802.16e™

**IEEE Standard for
Local and metropolitan area networks**

**Amendment 2: Physical and Medium Access
Control Layers for Combined Fixed and Mobile
Operation in Licensed Bands**

**IEEE Std 802.16e™-2005 and
IEEE Std 802.16™-2004/Cor1-2005**
(Amendment and Corrigendum to
IEEE Std 802.16-2004)

Figure 224—AAS Diversity Map Frame Structure

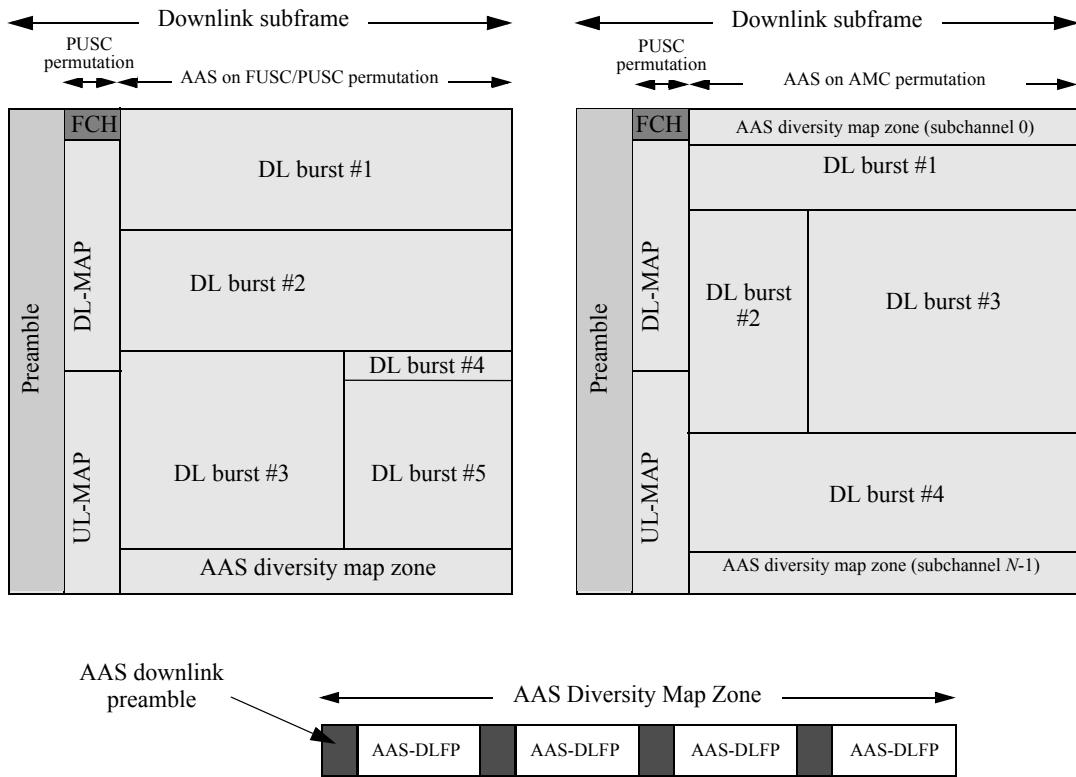
Replace Figure 224 with the following figure:

Figure 230—Mapping order of FAST-FEEDBACK messages to the FAST-FEEDBACK region

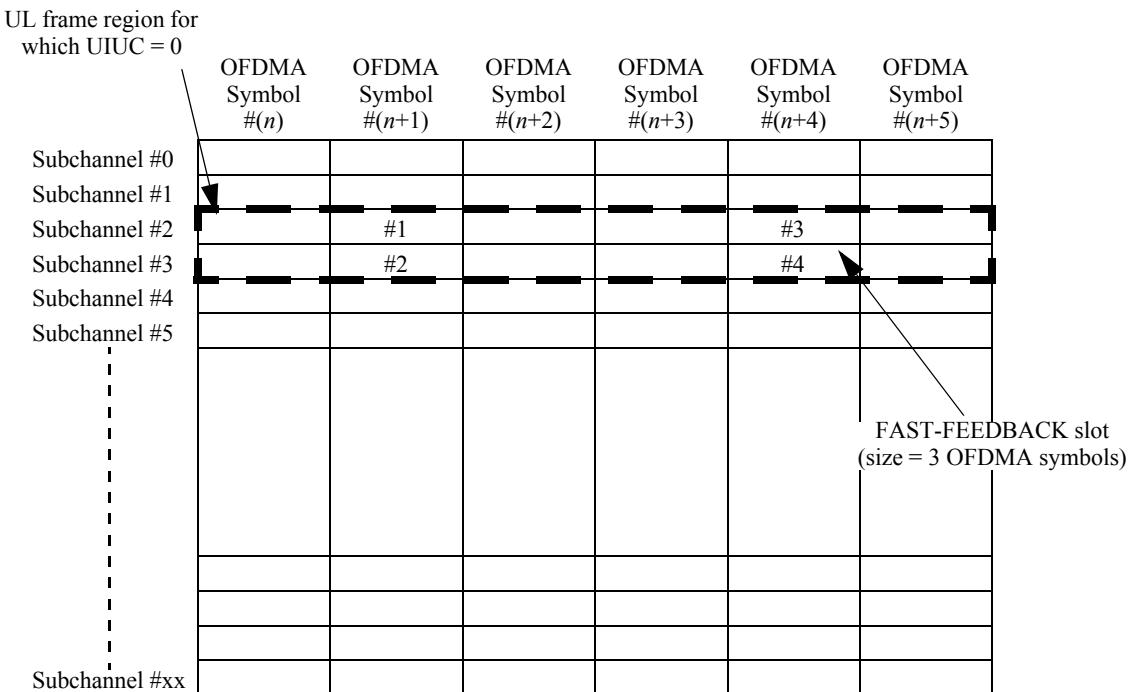
Replace Figure 230 with the following figure:

Figure 245—Cluster structure for STC PUSC using 2 Antennas

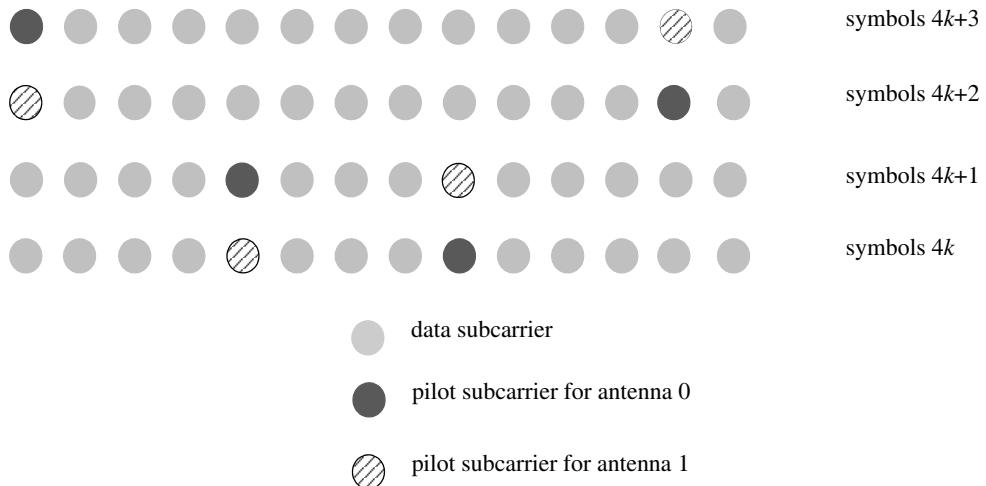
Replace Figure 245 with the following figure:

Figure 247—STC usage with FUSC

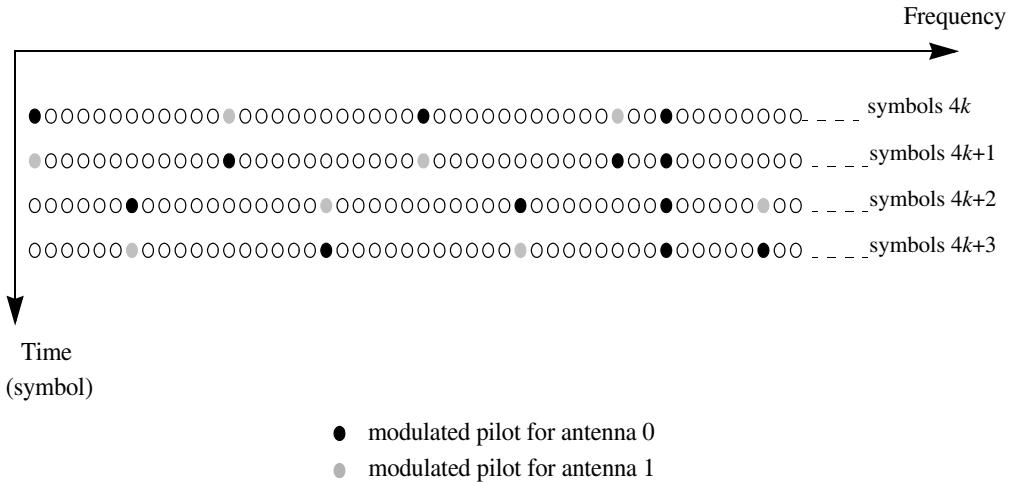
Replace Figure 247 with the following figure:

Figure 251a—STC usage with FUSC

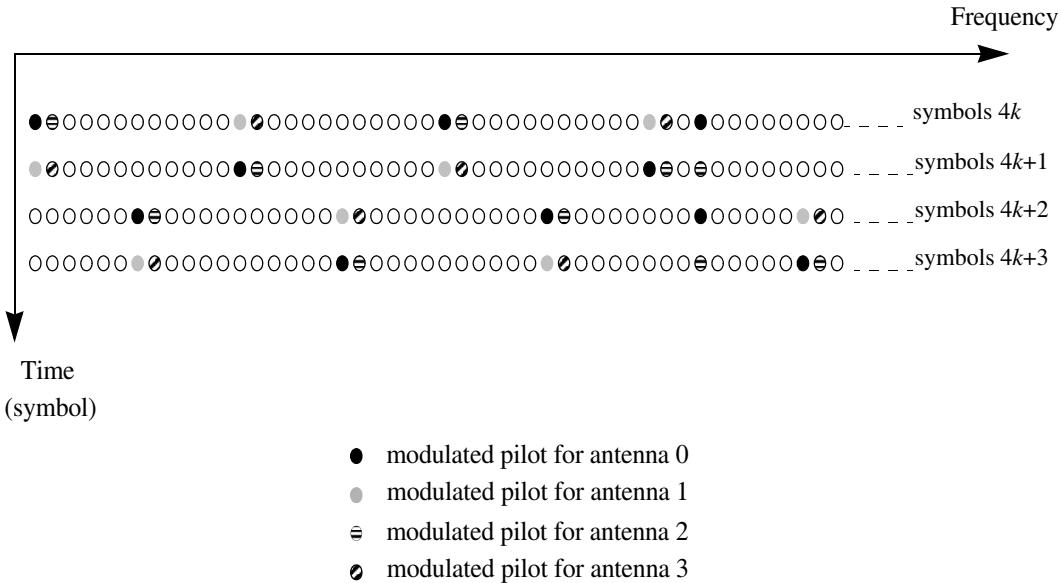
Insert new Figure 251a:
